SUPPLEMENTARY COMMENTS ON THE POINT SOLAR FARM FAST-TRACK SUBSTANTIVE APPLICATION

Original comments provided: 19 February 2026

Supplementary comments provided: 12 March 2026

Figure 3.8: Site Access Plan Route connecting SH8(yellow) to the local site access route(blue)

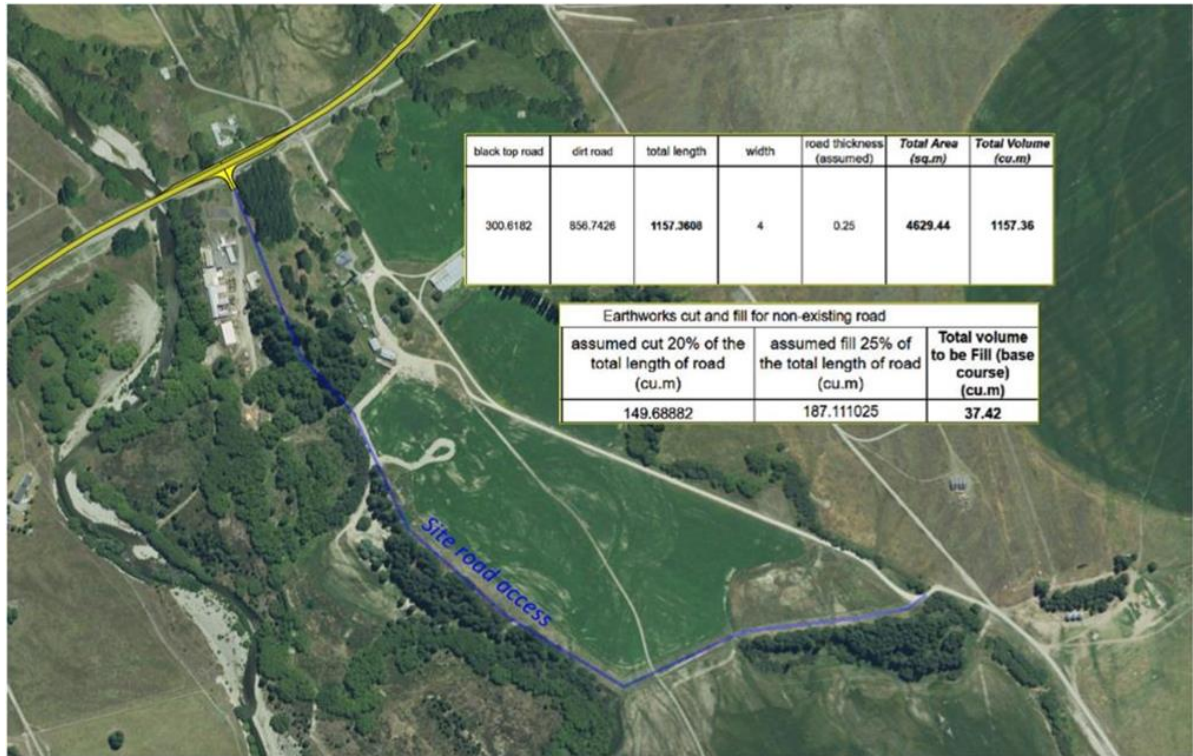
12. We strongly oppose the Applicant's use of the right of way over Lot 1 for any purposes, including 'Operational Phase' traffic, for the reasons set out in our original comments.
13. In fact, it appears (from Mackenzie District Council's review of the Application dated 11 June 2025², and from our legal counsel's review³) that the application proposed that all access to the solar farm site be **exclusively** via [REDACTED] (i.e., not using the easement over our Property). On this basis, it appears that the application does not seek (and therefore has not assessed the effects of) any use by the Applicant of the easement over our Property. Given this, use of the easement over our Property by the Applicant is not able to be authorised as part of this application.

14. On the basis that the Applicant has not applied to use the Right of Way over Lot 1, we respectfully request if the Panel is minded to grant consent:
 - (a) A condition stating that the right of way over Lot 1 DP 470213 (granted by Easement Instrument 8634143.6) shall not be used for any purpose related to The Point Solar Farm;
 - (b) A condition requiring that access to The Point Solar Farm shall be limited to that shown on the plan labelled as Figure 3.8 above;

- (d) Comprehensive mitigation measures are required by way of consent conditions to avoid the effects (dust, noise, visual amenity, and vibration) of the use of the access route shown in the plan referred to in paragraph 11 above (labelled Figure 3.8) on us and our Property including:

- (i) Limits on the numbers and types of vehicles using the access route each day, specific to all phases of the project (being construction, operational, and decommissioning phases);

- (ii) The use of 'blacktop' proposed for the access way⁴ - we seek that the sealed length of the accessway be increased to the stream crossing point shown on the plan labelled Figure 3.8 above;

- (iii) That existing trees and vegetation along the access route shown on the plan labelled Figure 3.8 above shall not be trimmed to lower than their existing heights and shall not be removed, to retain screening of the access way from our Property. Any dead or diseased vegetation shall be replaced with fast growing trees within the next growing season;

10. In an email dated 11 March 2026, the Applicant confirmed:
 - (a) “[The right of way over Lot 1 (granted by Easement Instrument 8634143.6)] **will not** be used for any construction traffic, heavy vehicle movements or construction-related activities associated with The Point Solar Farm project.”

- (b) “Access during the construction phase will be via an alternative construction traffic route specifically developed to entirely bypass [the] Property (Lot 1 DP 470213 and Section 3 SO 432605).”

- (c) “[The Applicant] intends to maintain and exercise [their] legal rights under the existing easement for access during the operational phase of the solar farm. [...] Operational access is expected to be limited to light vehicles only (for routine maintenance, monitoring, and emergencies), and any use will be consistent with the rights implied in the easement under the Land Transfer Regulations and Property Law Act.”

Figure 3.8: Site Access Plan Route connecting SH8(yellow) to the local site access route(blue)

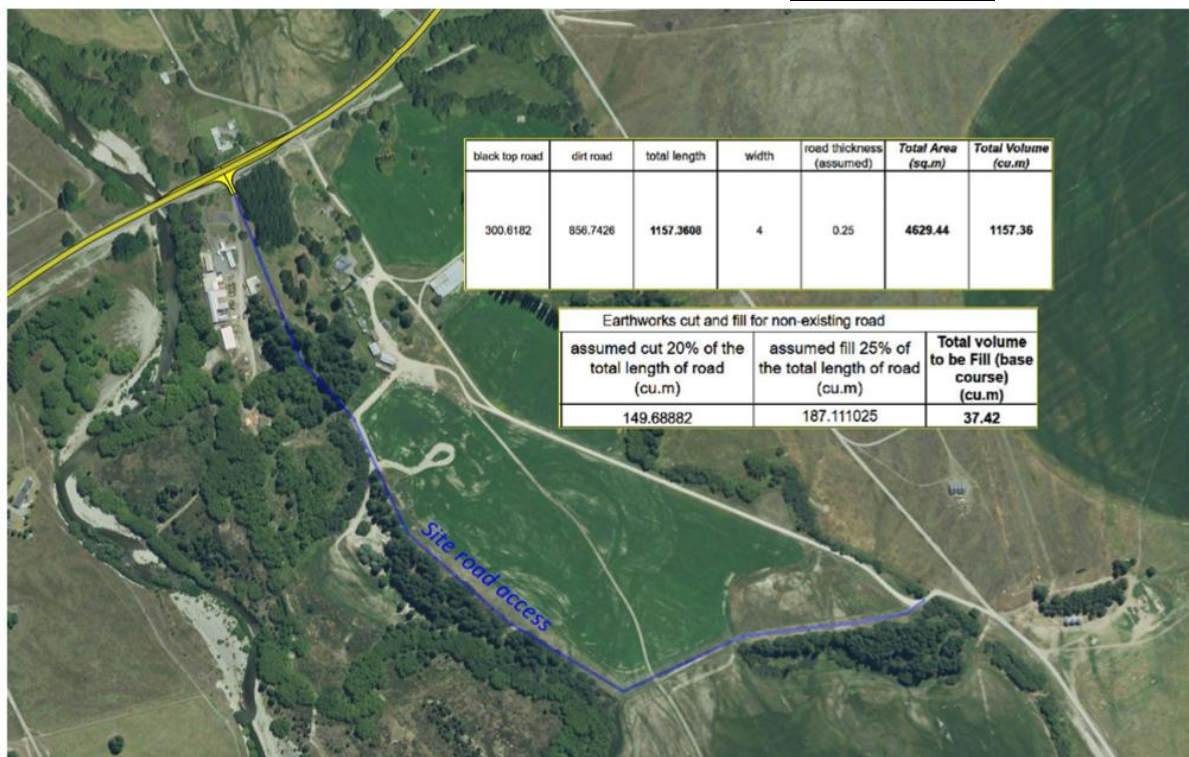
Figure 3.8 (shown) in that document details the route from the highway to the start of the larger [redacted] area, which demonstrates the bypassing of the [redacted] property.

The intention is to blacktop the road past the buildings on the [redacted]

Figure 3.1: The Site Entrance Perspective View

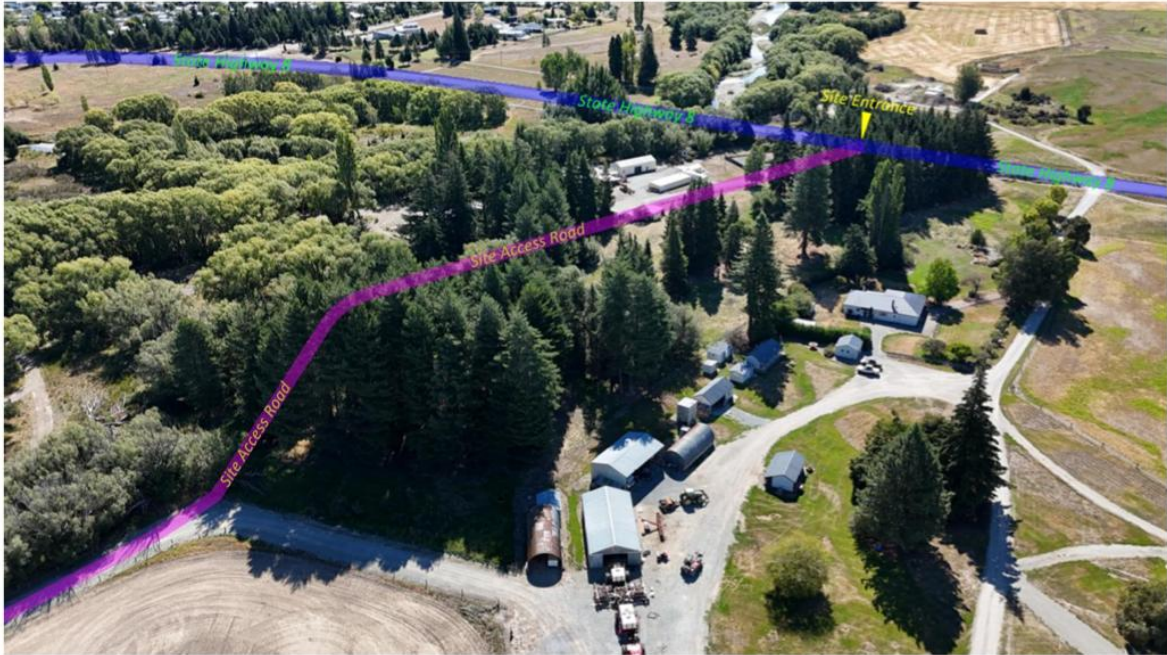
Figures 3.1 and 3.3 (below) are drone photos showing the route leaving the highway, and 180 degrees from that photo, towards The Point block.

Figure 3.3 shows the [redacted] and how the entire track across that title is avoided.
